SUBJECT: Nine Mile Point Nuclear Station
Unit No. 2; Docket No. 50-410

License Amendment Request Pursuant to 10 CFR 50.90: Application of Alternative Source Term – Response to NRC Request for Additional Information (TAC No. MD5758)

**NINE MILE POINT UNIT 2
RESPONSE TO NRC REQUEST FOR ADDITIONAL INFORMATION
REGARDING PROPOSED REVISION TO
THE ACCIDENT SOURCE TERM**

Figure 4-1
Reactor Building Shine Source – Photon Energy Spectrum Comparison, AST vs. CLB

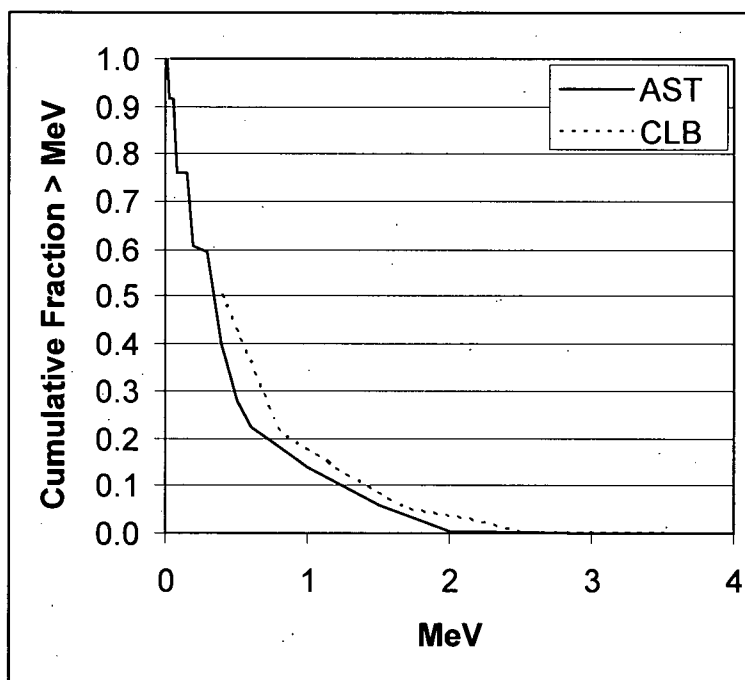
In Appendix J to the LOCA design analysis (H21C-106) of Attachment (7) to the May 31, 2007, LAR, it is shown that the ratios of the activities calculated using RG 1.3, "Assumptions Used for Evaluating the Potential Radiological Consequences of a Loss of Coolant Accident for Boiling Water Reactors," to the activities calculated using an alternative source term basis are all greater than 1 for the reactor building cloud, control room filter, and external plume sources. However, for at least two of those sources, the reactor building cloud and external plume, specifically, the ratio is less than an order of magnitude and approximately equal to 2. This may be considered to be "slim" margin, given the uncertainty generally associated with calculations of shine doses through shielding. Often, this type of comparison lends itself to the inclusion of factors to account for uncertainty, but no such factor appears to have been included for NMP2.

Therefore, please discuss how uncertainty in shine dose was addressed when making the comparison between the activity associated with the magnitude of shine sources, calculated the historical way and using the alternative source term.

The only way that the control room shine dose could be greater for the AST than for the CLB would be if the AST photon energy spectrum were considerably "harder" (i.e., the total energy concentrated in higher energy photons). In such a situation, it is possible (when shielding is present) for a smaller total energy to produce a higher dose.

A photon energy spectrum comparison of the AST and CLB sources for the reactor building shine source is shown in Figure 4-1 below:

This comparison shows that the CLB reactor building shine source energy spectrum is actually harder than that of the AST. Therefore, the reactor building shine dose, given that all elements of the CLB reactor building shine dose model for the control room other than the source strength remains unchanged, must be higher for the CLB RG 1.3 source term than for the AST source term.

Figure 8-1
Generic Comparison of Activity Removal Efficiency as a Function of $A_d V_d / V_{dot}$

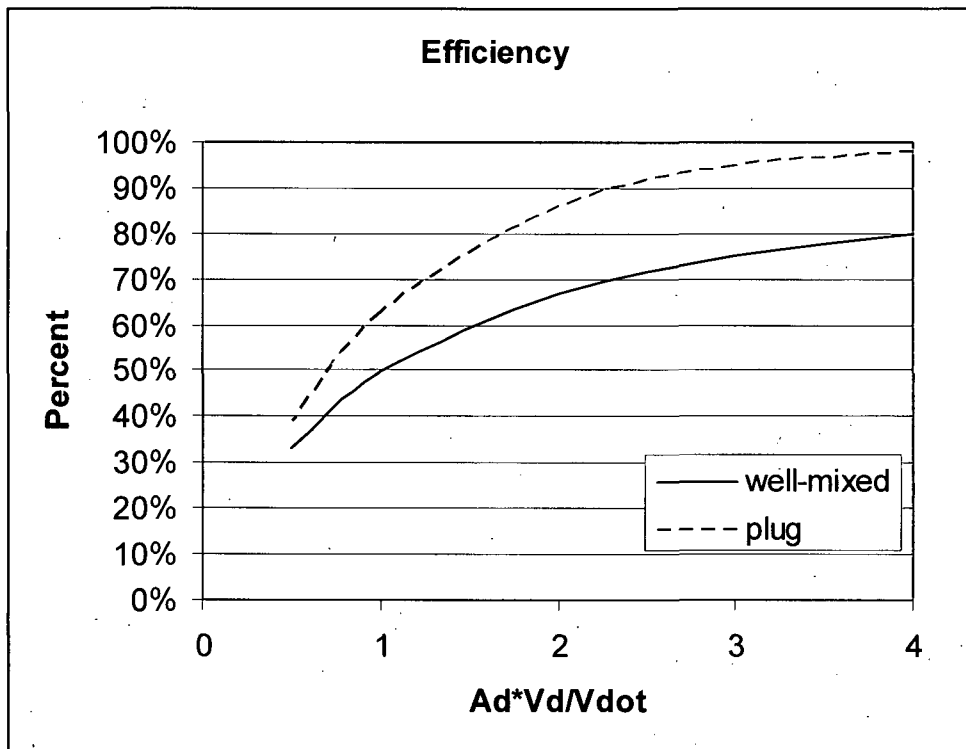
AEB-98-03 is regarded as a "well-mixed" model, where activity is assumed to immediately be available for release to the environment. Although the activity concentration where it is released will "build up" and peak over time, the assumed release of activity to the environment begins with the onset of gap release from the core. As cited in the May 31, 2007, LAR, AEB-98-03 is used as the basis for the activity deposition and transport model implemented for the MSIV leakage pathway of the LOCA analysis. However, credit is taken for the current licensing basis delay in the transport of primary containment activity through the bypass pathway (i.e., main steam line, etc.). This treatment is more consistent with a plug, or slug, flow model, which in many ways can be viewed as the antithesis of a well-mixed model.

Please explain and justify why crediting delay time in the AEB-98-03-based, well-mixed, modeling of NMP2 bypass pathways is acceptable. Also, please explain how doing so is more conservative than not.

As noted in AEB-98-03, Appendix A, during a design basis LOCA, the flow pattern in the main steam line could be plug flow, well-mixed flow, or some combination of the two. If temperature gradients exist along the length of the pipe, then some degree of mixing would occur. For the same leak rate into a main steam line, plug flow is expected to result in less offsite release than well-mixed flow because the concentration of the material released to the environment is at the concentration of the material in the plug at the release point (i.e., the end of the pipe). Plug flow effectively results in a longer fission product transport time in the pipe and more deposition in the pipe. There is inherent conservatism in the well-mixed removal efficiency calculation (alluded to in AEB-98-03) that is illustrated in the following generic comparison of removal efficiency as a function of $A_d V_d / V_{dot}$ (Figure 8-1), where A_d is the deposition area, V_d is the deposition velocity, and V_{dot} is the volumetric flow in the pipe:

For example, when $A_d V_d / V_{dot} = 4$, the penetration (i.e., $1 - \text{efficiency}$) is an order of magnitude greater for the well-mixed case than for the case using plug flow.
